CITY of NOVI CITY COUNCIL

Agenda Item 2
May 6, 2019

SUBJECT: Consideration of the request of Orville Properties, LLC for Tentative Approval of the First Amendment to the previously-approved Planned Rezoning Overlay (PRO) Plan and Agreement, JZ18-24, Adell Center PRO. The subject property is approximately 23 acres and is located on Expo Center Drive (now Adell Center Drive), north of Grand River Avenue and south of I-96 in Section 15. The applicant seeks to revise the PRO Agreement to amend the approved layout for Units 6 and 7, common landscape areas, building signage, and location of accessory units.

CLIENT: ADELL CENTER
P.R.O. PLAN (OVERALL)
 43700 ADELL CENTER DRIVE - PARCEL NO. 22-15-476-056
 SECTION 15
 TOWNSHIP 15N RANGE 8E
 CITY OF NOVI, OAKLAND COUNTY, MICHIGAN

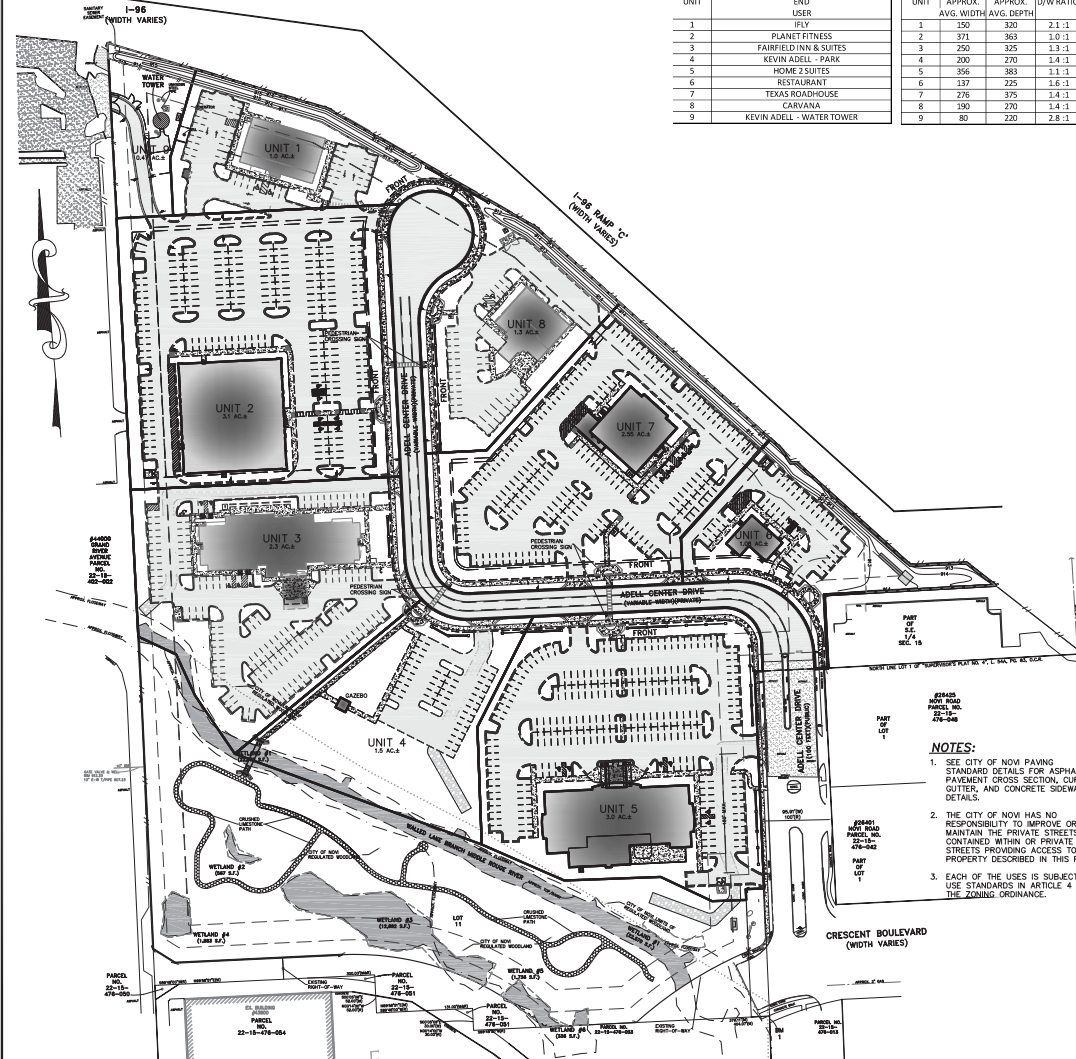
- 1. A note shall be added to on Sheet 2, PRO Concept Plan, that each of the uses is subject to Use Standards in Article 4 of Zoning Ordinance;**
- 2. The following notes shall be removed from the PRO Concept Plan**

- a. A note on sheet 02 that refers to "The Users are as of 08-29-18 and will be updated as new users are determined".**
 - b. A note on sheet 03 and 04 that refers to "Internal lot lines within the Adell Center Development are subject to move".**

- c. Building and Parking setbacks provided in a small inset on Sheet 2 as they conflict with the suggested deviations at August 22nd Planning Commission meeting;**

- 3. The applicant shall remove the parking reference summary from sheet 02 as the Planning deviation from standards of Sec. 5.12 for up to 5% reduction in minimum required parking will address the counts at the time of respective site plan approval as indicated earlier in this motion sheet;**

- 8. The applicant shall indicate the proposed decorative brick wall on Sheet 2, PRO Concept Plan;**
- 9. The applicant shall develop the road with a three-lane cross-section to further accommodate left-turning activities and provide a wider "buffer zone" for large vehicles entering/exiting the various facilities without entering into the opposing traffic through lane, at the time of Preliminary Site Plan approval;**

CLIENT: ADELL CENTER
P.R.O. PLAN (SOUTH)
43700 ADELL CENTER DRIVE - PARCEL NO. 22-15-476-056
SECTION 15
CITY OF NOV
OAKLAND COUNTY
MICHIGAN

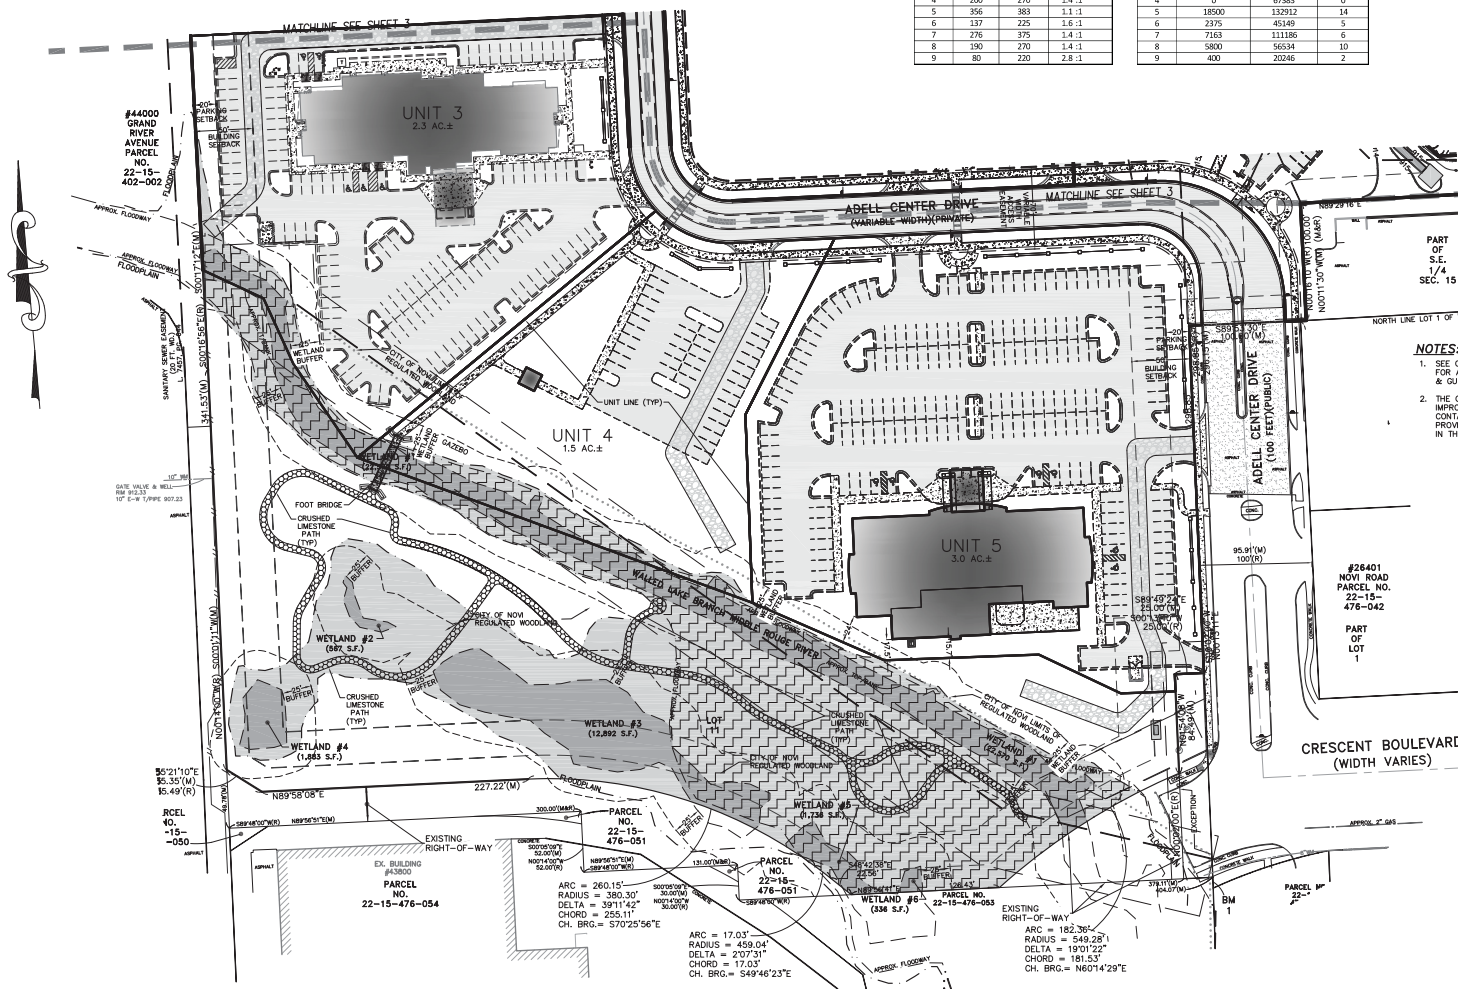
8. **UNIT 6:** Unit 6 is currently shown as proposed tenant. Please change it to restaurant. Parking calculations on sheet 4 refer to a retail use. Please revise the calculations to a restaurant use. The developer should contact Planning Department to confirm the final parking counts once a final user is determined

CLIENT: ORVILLE PROPERTIES, LLC.		DATE: 3-1-2019
UNITS 6 & 7 DRIVEWAY SEPERATION		DRAWN BY: RMS
ADELL CENTER		CHECKED BY: DJL
SECTION: 15	TOWNSHIP: 1N	RANGE: 8E
CITY OF NOVI		SCALE: HOR 1" = 50 FT. VER 1" = 50 FT.
OAKLAND COUNTY		FBK: SE1
MICHIGAN		CHF: JOB# 17-334

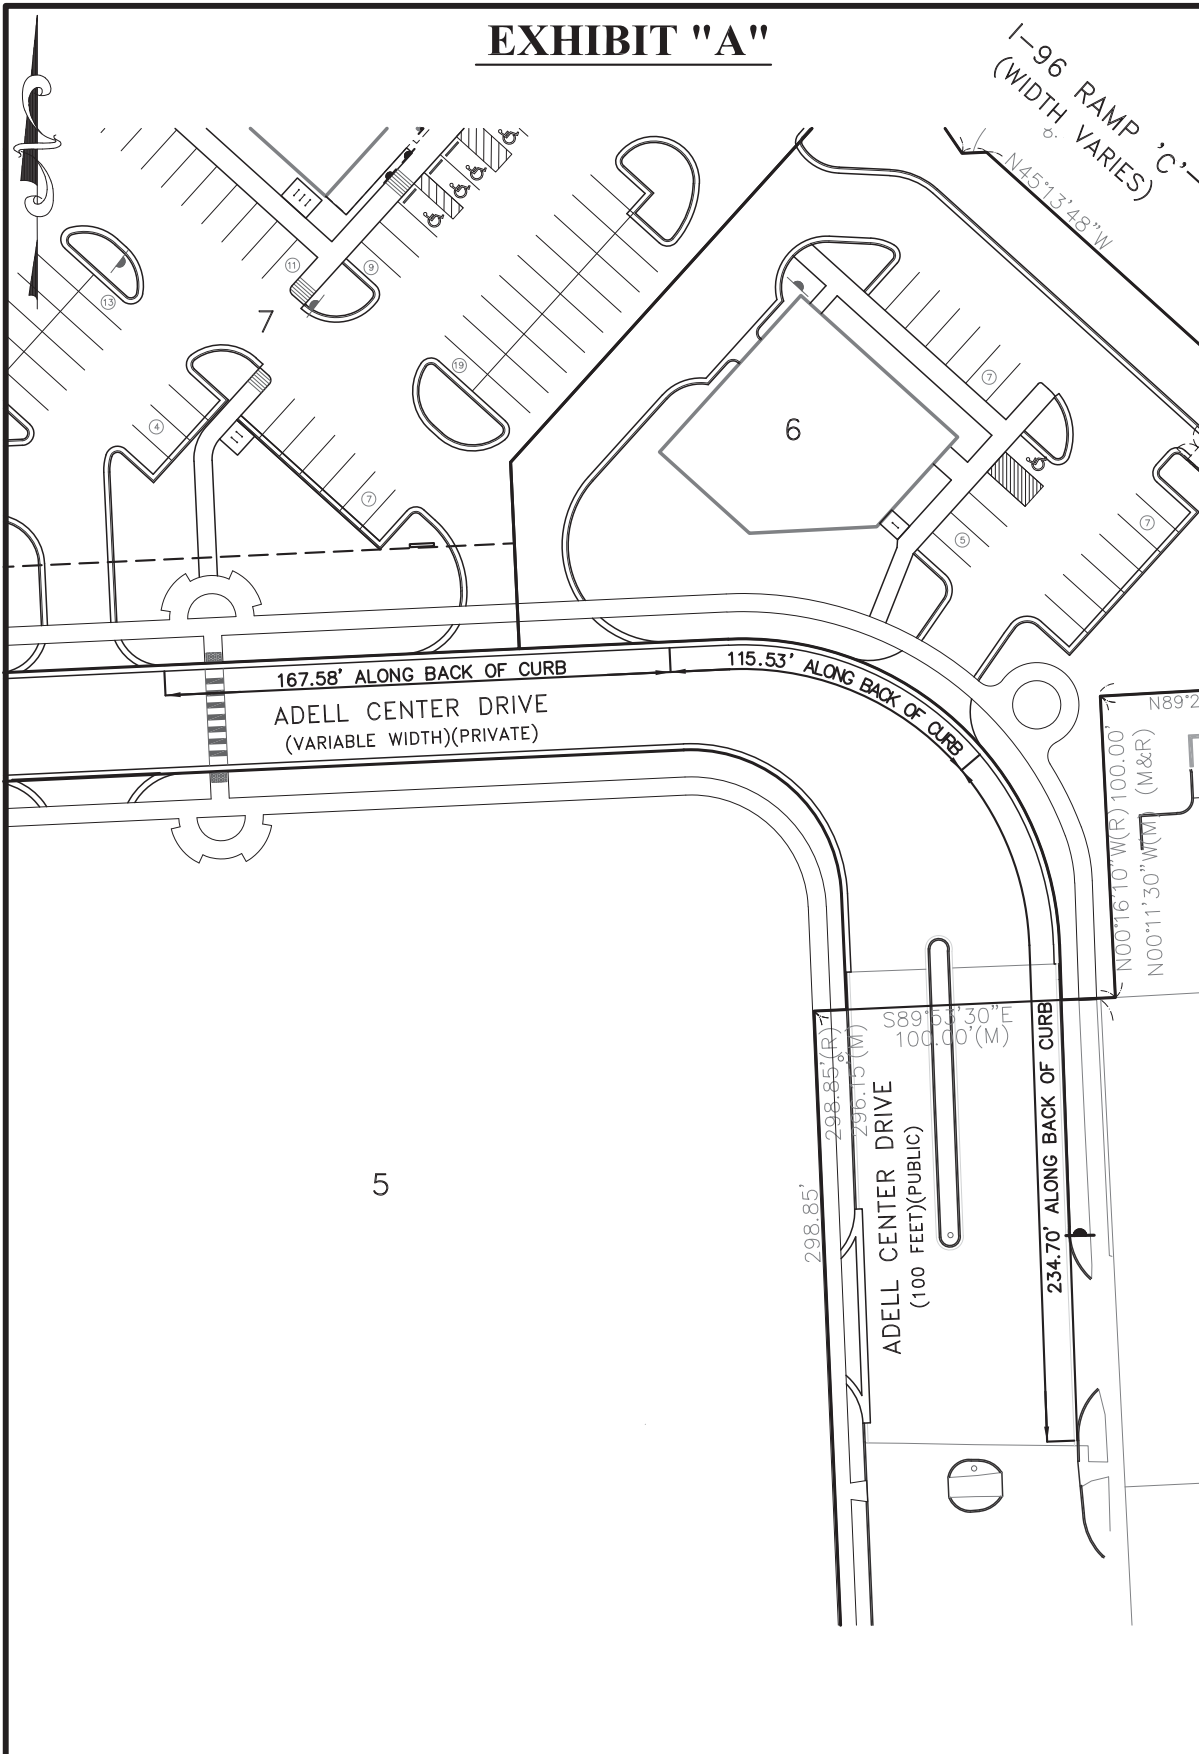
- b. Unit 6 shall have only one primary access off of Adell Drive, which is currently shown as shared with Unit 7 on the revised PRO plan.
